JOINT REGIONAL PLANNING PANEL (Sydney East Region)

JRPP NUMBER:	2015 SYE 025
DA NUMBER:	LDA2015/0031
LOCAL GOVERNMENT AREA:	City of Ryde
PROPOSED DEVELOPMENT:	Construction of three (3) residential flat buildings comprising 422 apartments (168 x 1 bed, 215 x 2 bed, 39 x 3 bed), basement car parking and construction of a single storey commercial building.
STREET ADDRESS:	116 – 122 Bowden Street, Meadowbank
APPLICANT:	Rothesay Avenue Developments Pty Ltd
NUMBER OF SUBMISSIONS:	11 objections
REGIONAL DEVELOPMENT CRITERIA (SCHEDULE 4A OF THE ACT):	General Development over \$20 Million
LIST OF ALL RELEVANT S79C(1)(a) MATTERS:	Environmental Planning and Assessment Act, 1979 State Environmental Planning Policy (State and Regional Development) 2011 State Environmental Planning Policy No 55 – Remediation of Land (SEPP 55) State Environmental Planning Policy No 65 – Design Quality of Residential Flat Buildings (SEPP 65) State Environmental Planning Policy (Building Sustainability Index: BASIX) 2004 (BASIX) State Environmental Planning Policy Plan (Sydney Harbour Catchment) 2005 (Deemed SEPP) (Sydney Harbour SREP) State Environmental Planning Policy (Infrastructure) 2007 Ryde Local Environmen

Figure 9. Sketch plan showing revised configuration of ground floor entries.

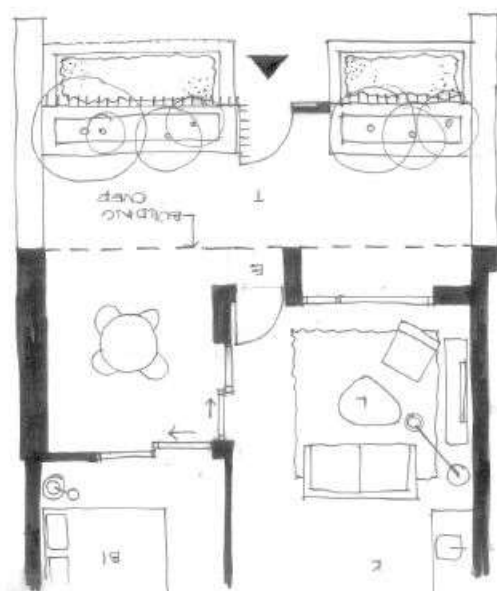
In response to concerns regarding external access to ground floor entries of apartments from Nancarrow Avenue and Bowden Street, the applicant has submitted a sketch plan illustrating the repositioning of hard landscaping and a centrally located gateway as proposed for Stage 6 by way of example (See sketch plan in Figure 9). It is considered that the principle of the proposed amendments are satisfactory as it will provide greater distinction to the door entry. As such formal revised plans ground floor entries to Bowden Street and Nancarrow Avenue for Stages 8 and 9 and details will be required by condition. (See condition number 2).
